New Dwelling
 Ty Capel
 Llanbedr DC
 Nr Ruthin, LL15 1UT
 for Mr & Mrs R. Tidd

APPLICATION NO: 16/2018/0027/ PF

PROPOSAL: Erection of 1 no. dwelling (amended details to previously approved/implemented scheme ref. 16/294/96)

LOCATION: Ty Capel (former Llwynedd Chapel) Llanbedr Dyffryn Clwyd Ruthin LL15 1UT

Proposed Block Plan
 Scale 1:200

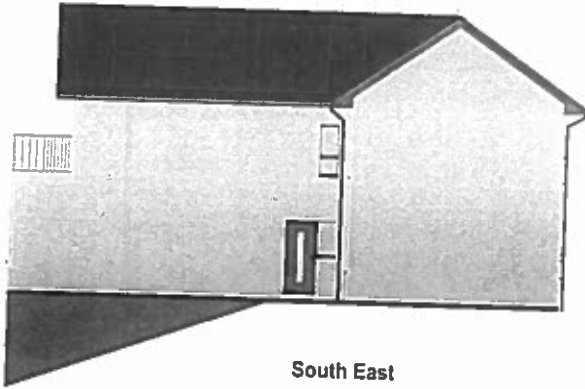
The revised plans do not answer our original objection, especially the destruction of a large section of an historic stone wall, which thus remains our view

The proposal does not have a safe access and the increase in vehicular movements would have an adverse impact upon highway safety

Representations have been received that raise concern about the impact upon highway safety in the form of obstructing visibility at the junction, unacceptable increase in vehicular movements, and substandard access onto the A494. The Welsh Government has been consulted in this respect and they have not raised an objection and have submitted suggested conditions to deal with the alterations to the access onto the trunk road and to prevent surface water run off onto the trunk road. The Public Rights of Way Officer has not raised an objection, but agrees that the method of dealing with surface water should be a condition. The Public Rights of Way Officer has also requested that a visual demarcation between the public bridleway and the additional 2 metres of tarmac provided by way of a planning condition. The Highway Officer does not raise an objection to the proposal.

The proposal involves the creation of a new vehicular from the public bridleway into the site. Land from within the site is to be lowered to that of the Public bridleway to allow its width to be increased from 2 metres to 4 metres along the width of the site frontage. A new 6m radii curve to the access onto the A494 is proposed. These details all roughly accord with the previously approved plans.

3. The access shall be laid out and constructed strictly in accordance with the approved plan RET/2018/03 REV C and shall be completed before the dwelling is occupied.

Proposed House South-East and
North-East Elevations
Scale 1:100

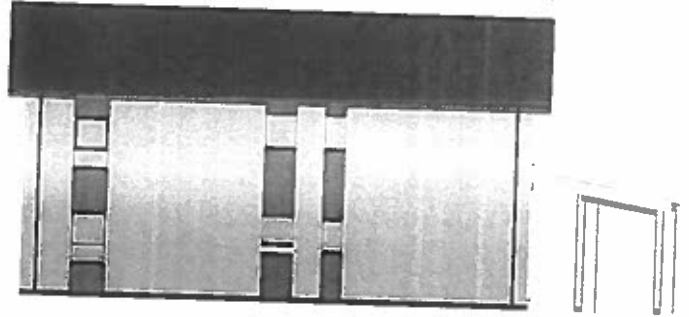
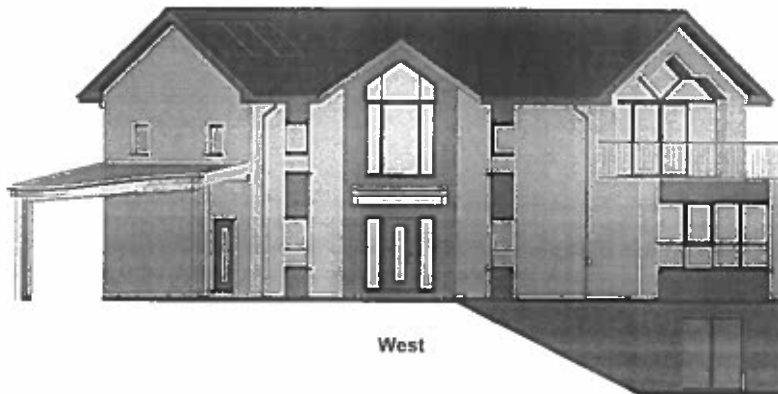
2. Scale of the proposed development does not reflect the existing dwellings in the immediate area

The development is still a three storey dwelling. The Council supports the representation made by Clwydian Range and Dee Valley AONB Committee:

"The committee would favour the three storey section being reduced in scale to two storeys which will have the effect of stepping the building up the hillside which will reduce its impact and better integrate the development into the local topography."

With regard to the points raised by the Community Council, it is Officers' opinion that the current proposal is almost identical in scale to that as previously approved. Whilst noting the inclusion of a lower ground floor in the current scheme, this would be partially set into the ground and would not make the dwelling appear any higher from most angles. It is also considered that to implement the previously approved scheme and achieve the approved ground floor level, the ground would have to be built up by approximately 2.5 - 3 metres, so the impact would be similar. Having regard to the topography of the land to the rear of the proposed dwelling, the established trees, and the presence of other large dwellings on higher ground, it is not considered that the proposed dwelling would appear obtrusive within the landscape. In terms of detailed design, it is considered that the omission of dormer windows results in a less 'fussy' appearance than the previously approved scheme, and reflects other new development in the area.

In conclusion, it is considered that the scale and form of the proposed dwelling are in keeping with the character of the area. The choice of materials and layout are considered acceptable in this location. It is therefore Officers' opinion that the proposal would not result in a detrimental impact upon the visual amenity of the area, and the proposal therefore accords with the general aims of Policy RD 1.
